**BOUNTIFUL CITY**  
**PLANNING COMMISSION AGENDA**  
**Tuesday, April 7, 2020**  
**6:30 p.m.**

# Planning Commission Staff Report

**Subject:** Preliminary and Final Architectural and Site Plan Review for the Construction of a Credit Union Branch Office  
**Author:** Curtis Poole, Assistant City Planner  
**Address:** 260 North 500 West  
**Date:** April 7, 2020

**C400**  
 SITE PLAN

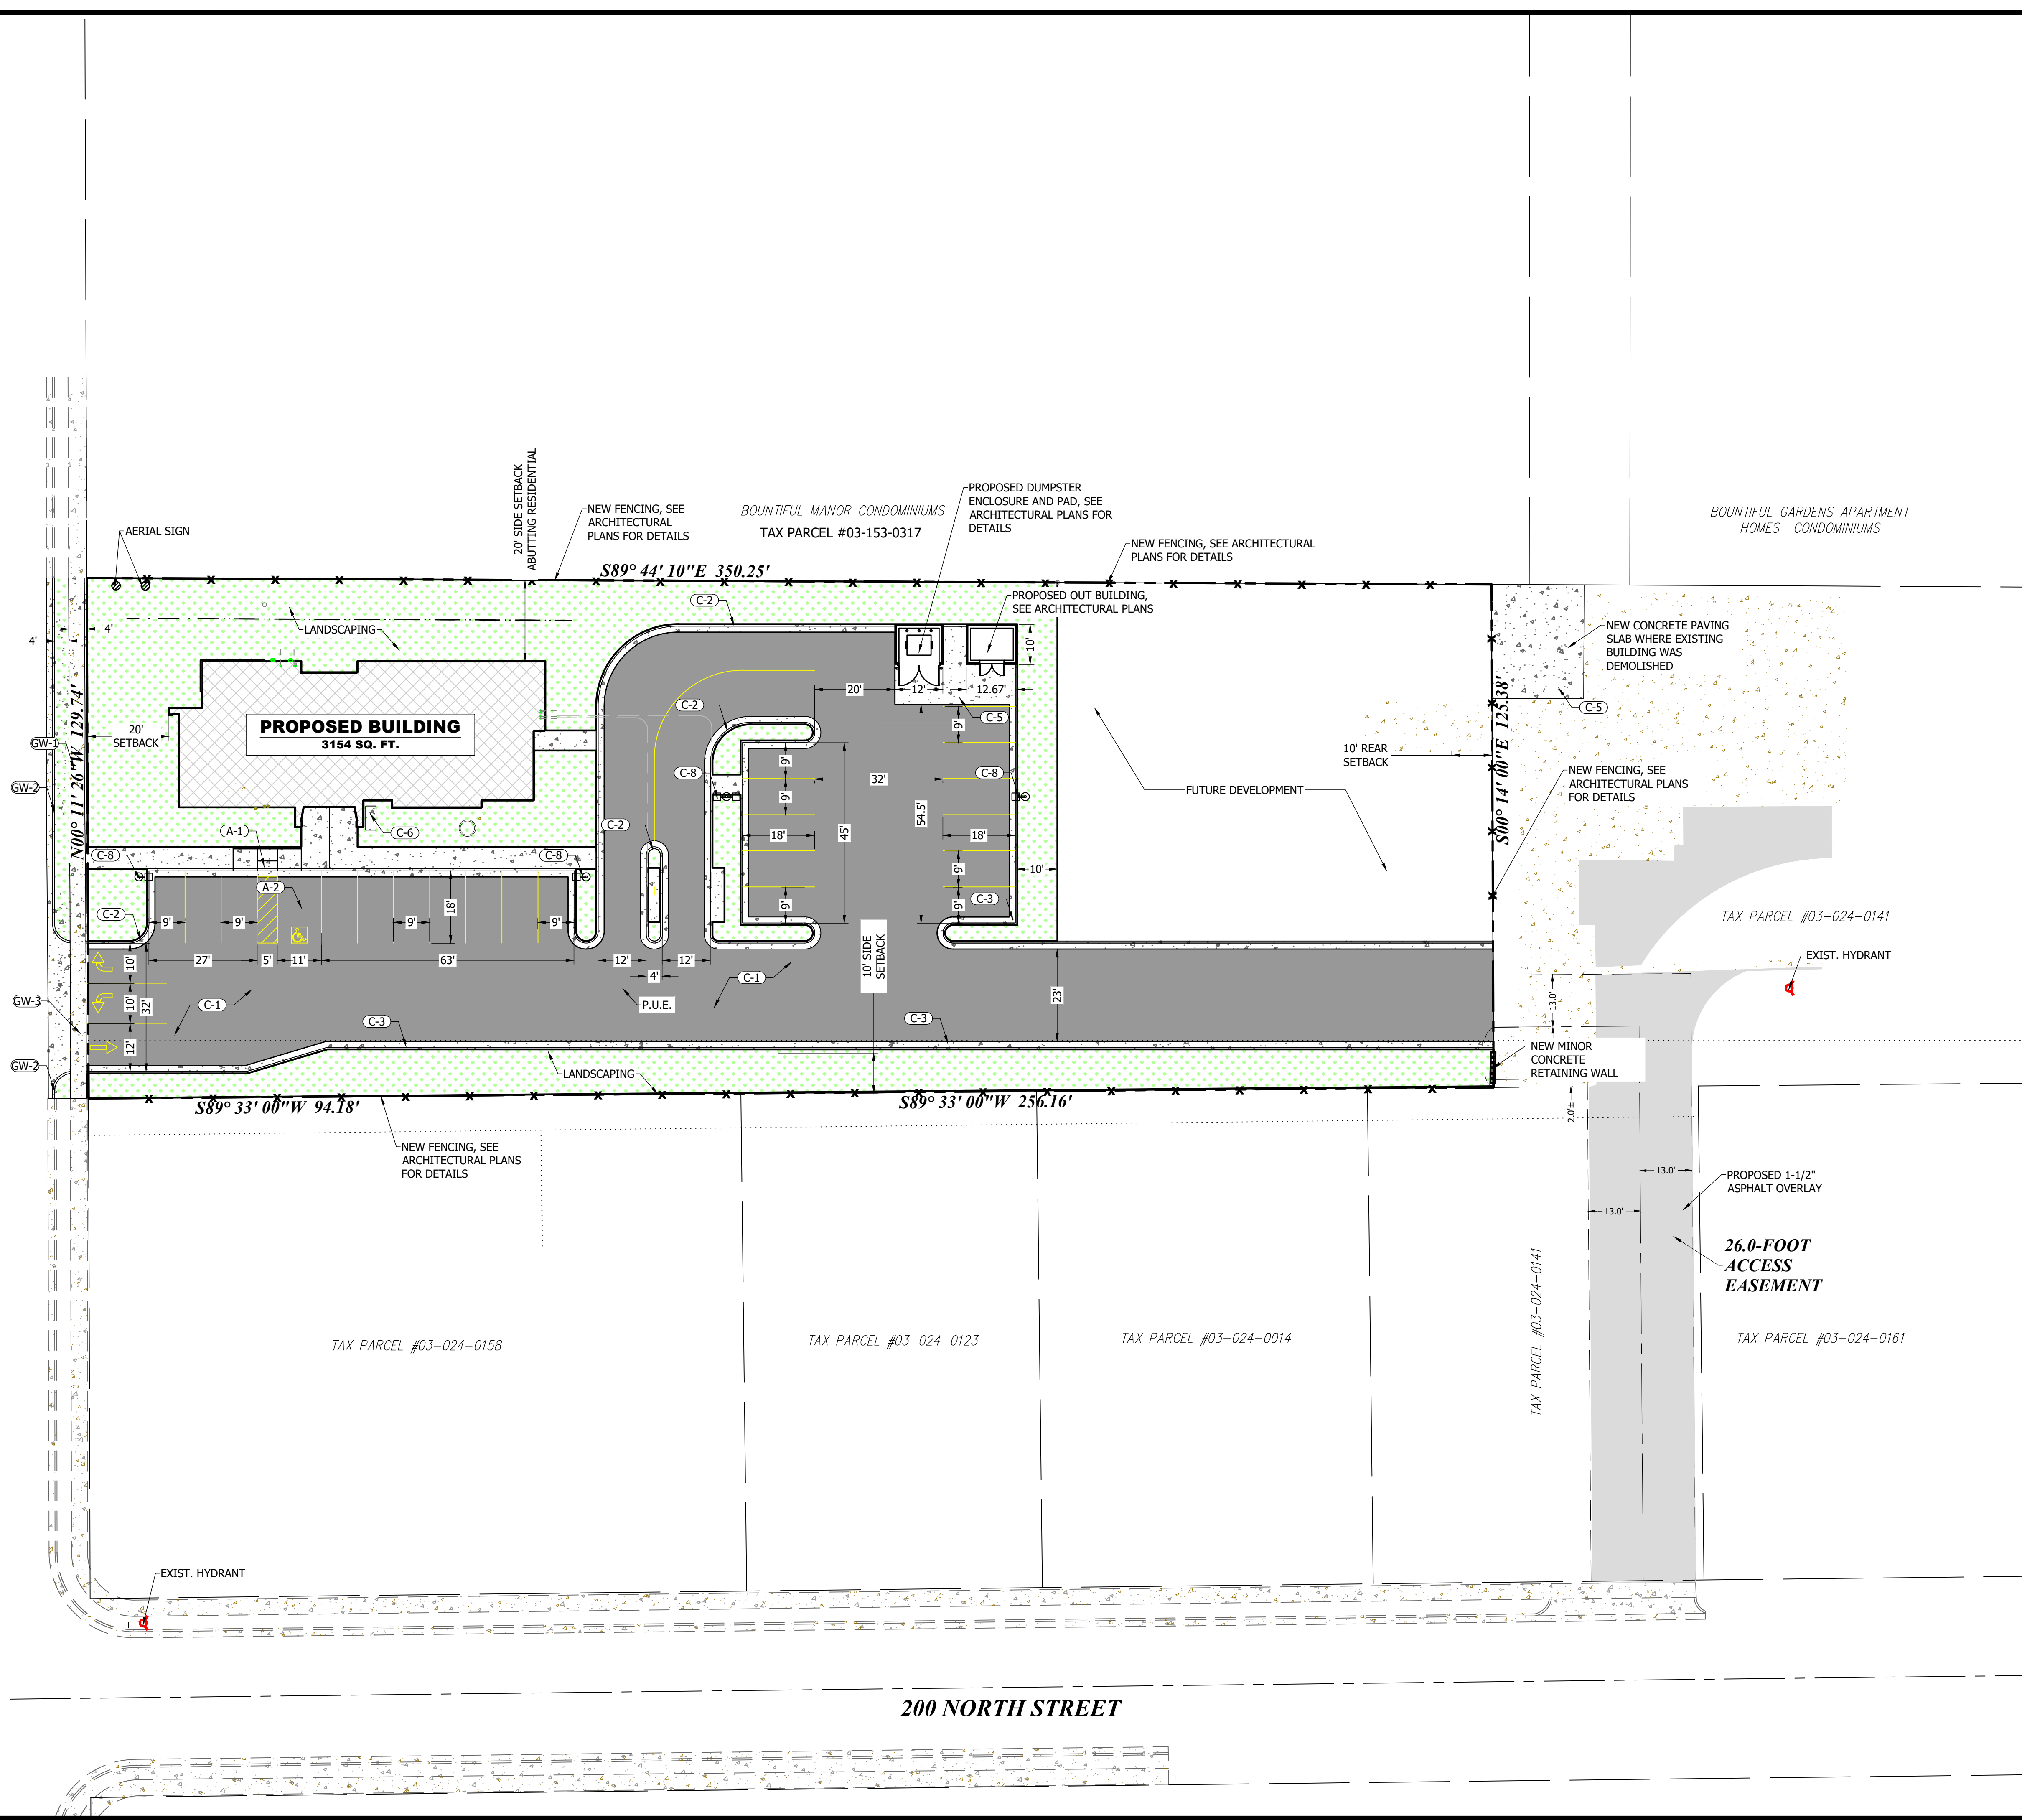
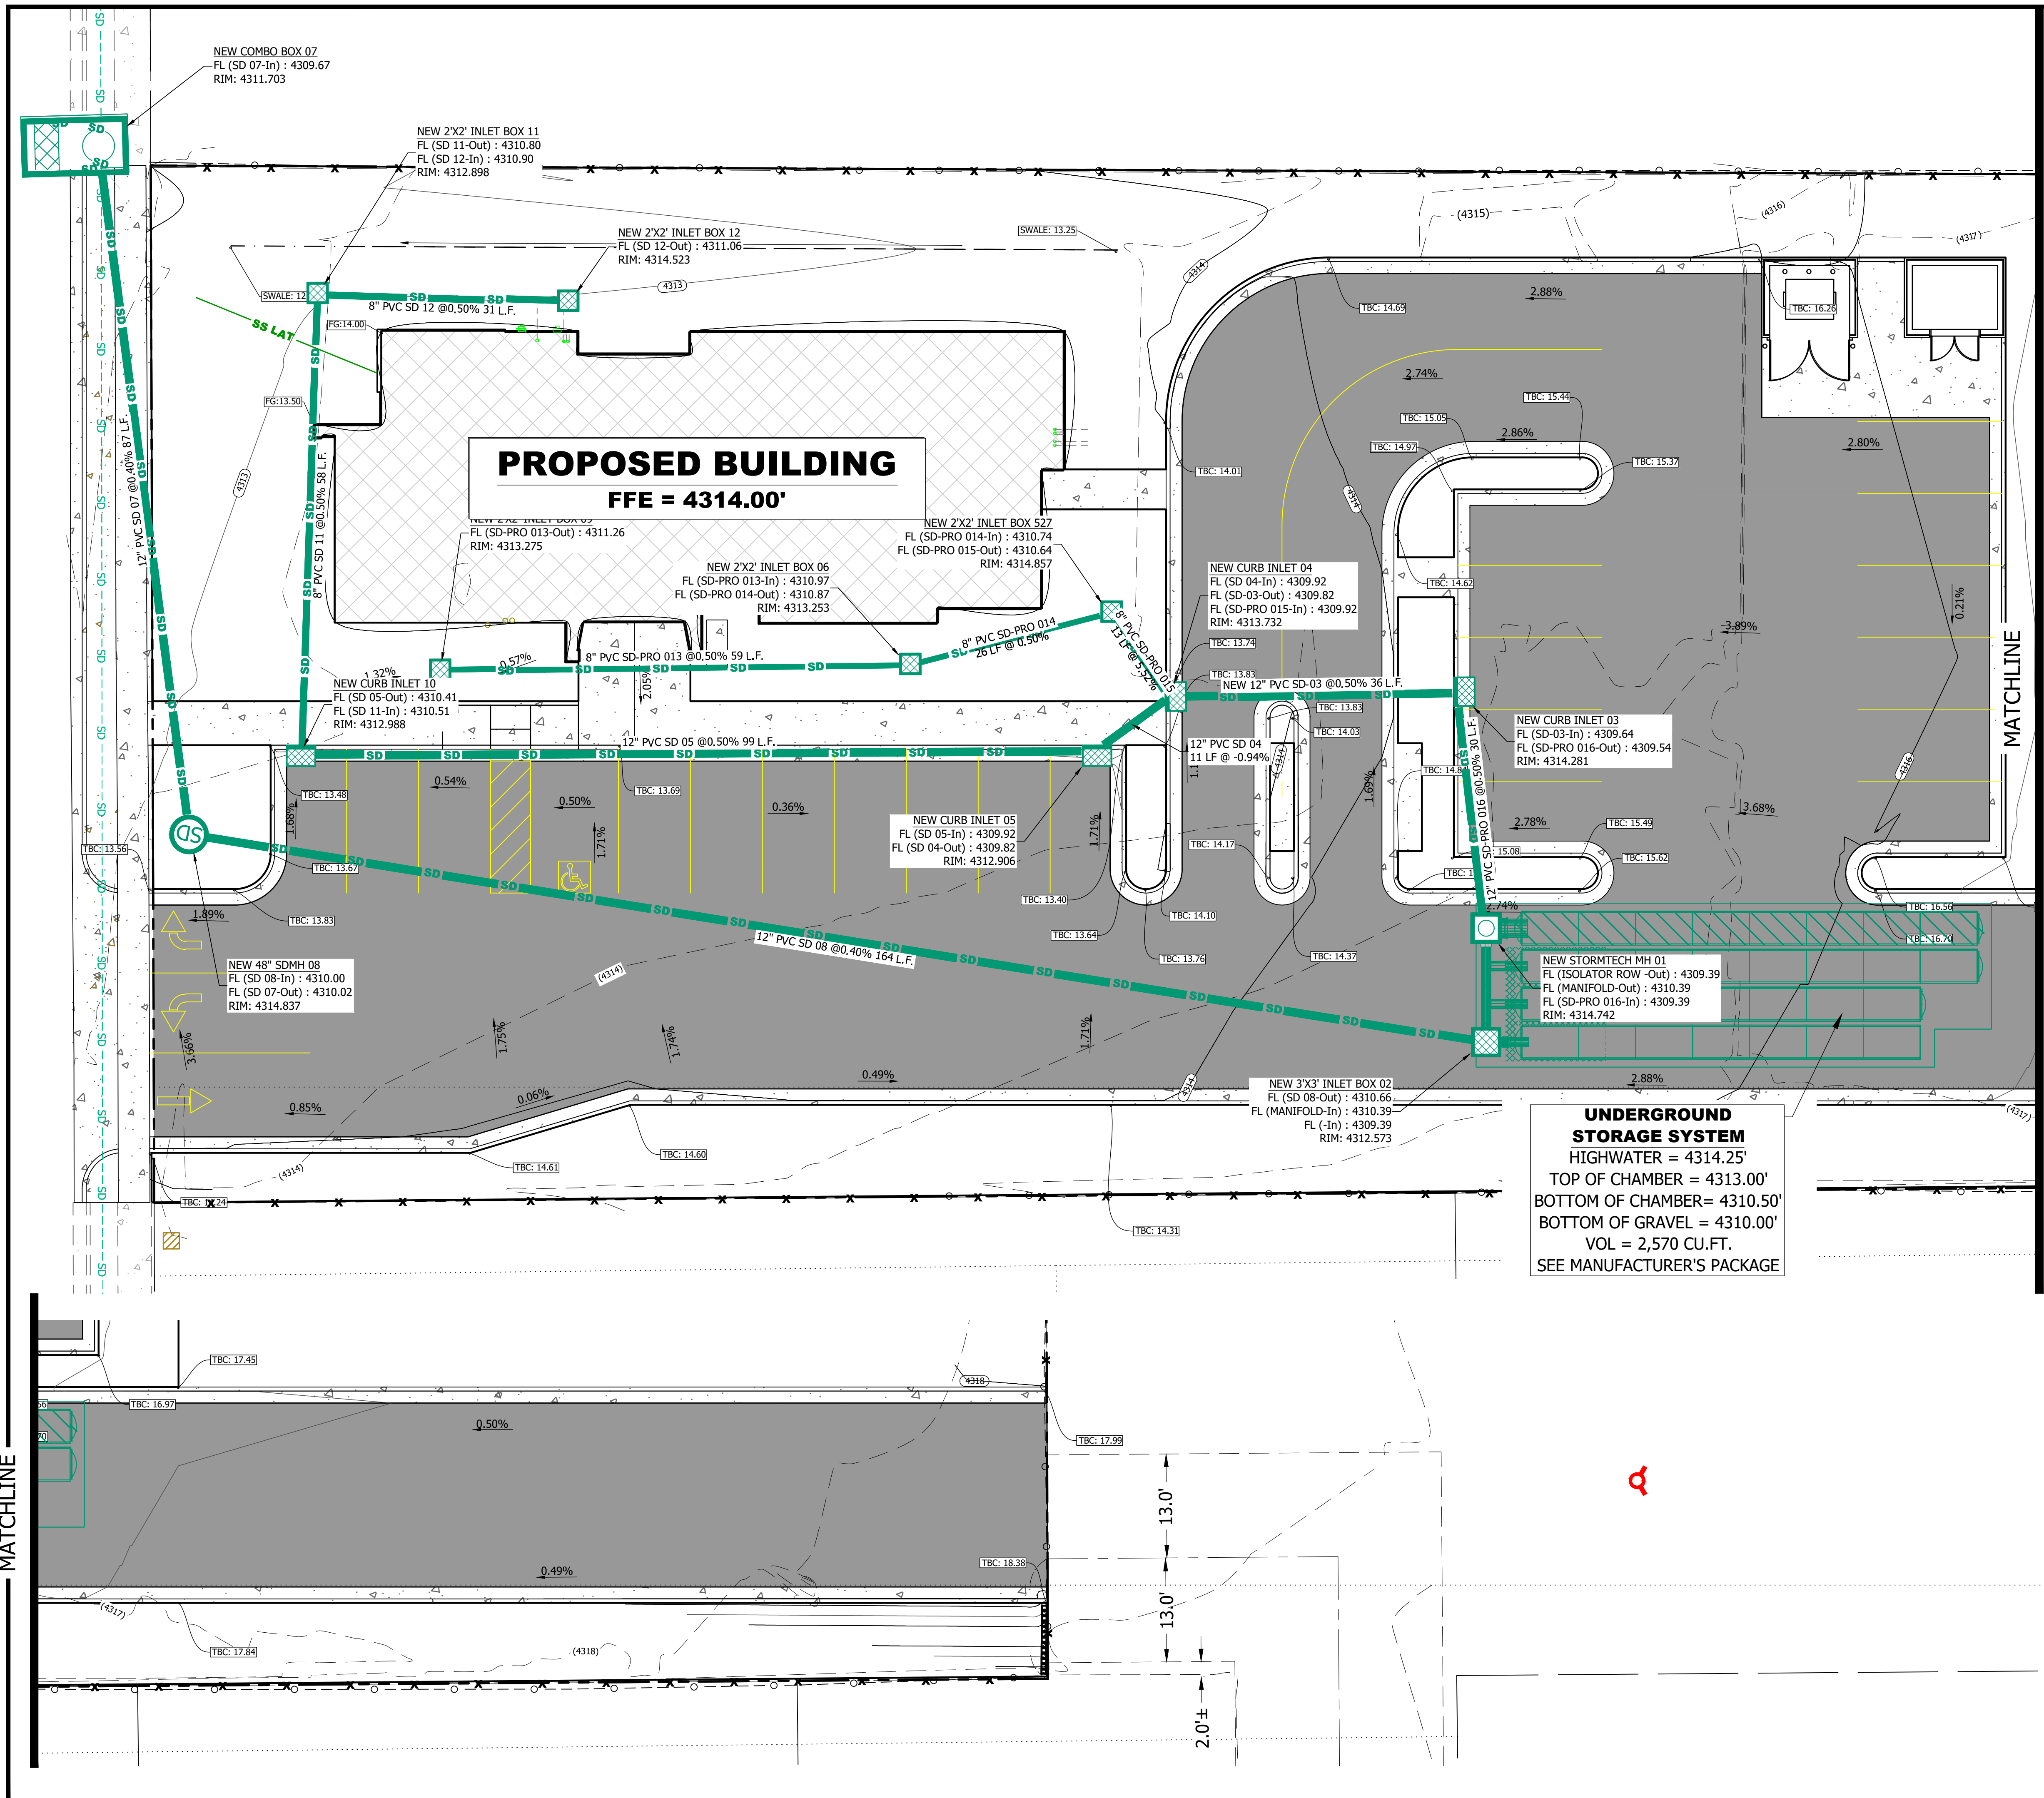
The Landscape Plan submitted by the Applicant shows they will provide five (5) additional trees; however, they are not indicating any trees adjacent to 500 West as required by Code. Staff and the Applicant request to further discuss the proposed Landscape Plan in relationship to the required street trees found in Bountiful Land Use Code § 14-16-109, C and 14-16-117 (included as attachments). Staff recommends the Planning Commission review the sections of Code and the location of trees within the proposed Landscape Plan.

The Applicant is requesting the Planning Commission review tree placement within their Landscape Plan to determine if substitutions of trees would be acceptable. The Commission may add a condition of approval to strictly follow the Code, requiring one (1) street tree be planted for every thirty-five (35) lineal feet of street frontage; or the Commission may add a condition of approval to allow for a substitution of tree types placed adjacent to 500 West with the same standards as street trees.

The Parking Plan submitted by the Applicant meets the standards of the Code including ADA required parking. To the east of the principal structure the Applicant is proposing two drive-through lanes with vehicular cueing meeting the standards of the Code. The driveway on the south will run through the property and connect to the property immediately adjacent to the east.

1. Complete any and all redline corrections.
2. All damaged curb, gutter and sidewalk along 500 West shall be replaced.
3. Receive UDOT approvals and permits for the drive approach and to work in the UDOT right-of-way.
4. Provide a SWPP and resolve any issues or concerns regarding storm water retention to the satisfaction of the City Engineer.
5. Apply separately for signage, including temporary signs, meeting the standards of the Code to be reviewed by Staff.
6. Pay fees and post an acceptable bond in the amount determined by the City Engineer.
7. Sign a Public Improvement Development Agreement.
